**City of Portland, Maine - Building or Use Permit Application**  
389 Congress Street, 04101 Tel: (207) 874-8703, Fax: (207) 874-8716

## BUILDING PERMIT REPORT

DATE: 19 June 2001 ADDRESS: 460 Warren Ave. CBL: 278-B-005  
REASON FOR PERMIT: To erect a 24'x32' Canopy over gas pump Is.  
BUILDING OWNER: Lee Mill's Petroleum Inc.  
PERMIT APPLICANT: \_\_\_\_\_ / CONTRACTOR TFC Canopy  
USE GROUP: U CONSTRUCTION TYPE: \_\_\_\_\_ CONSTRUCTION COST: 20,000.00 PERMIT FEES: 144

24'-0" x 32'-0" 2-COLUMN

SCALE: DO NOT SCALE  
DATE: 4-16-2001  
ENGINEER: CMS  
DRAWN BY: GRIGSBY  
DRAWING NO. 1

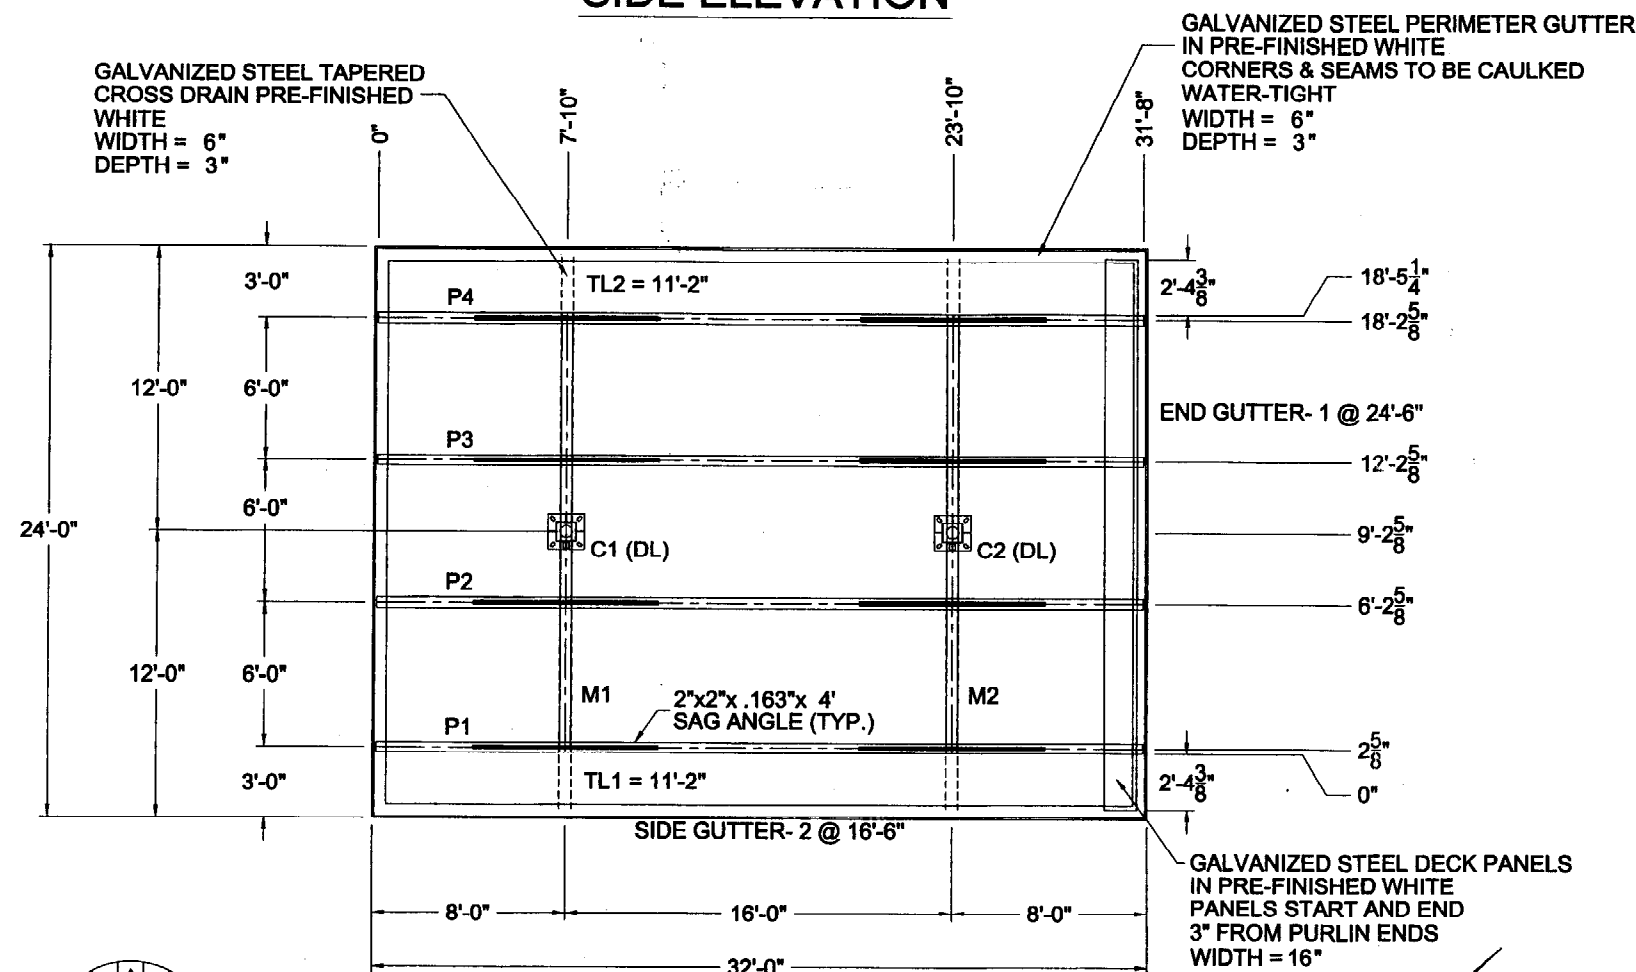
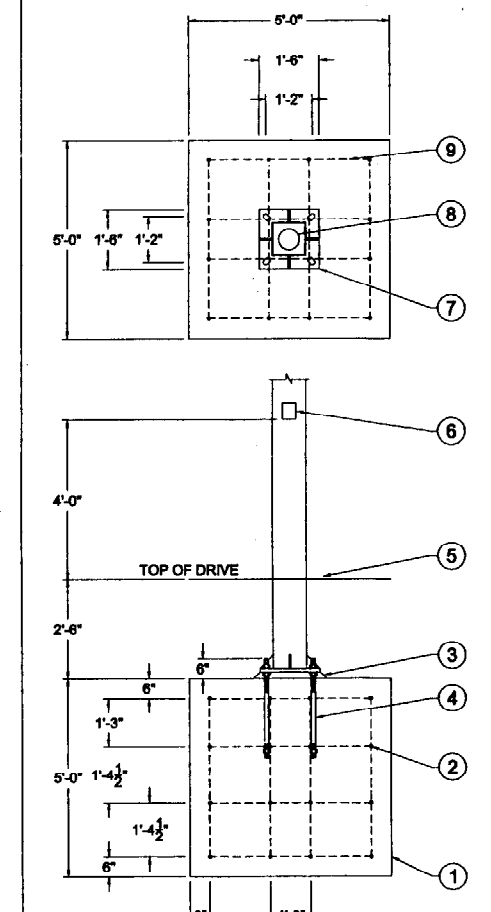
\* 38. *Your plans did not show snow load. Please verify with the design professional that the live load shown on the plans has the snow load included in the design, as per Chapter 16 of the BOCA National Building Code 1999. For this info. to me before work is started Sam Hoffses 207 874-8716.*
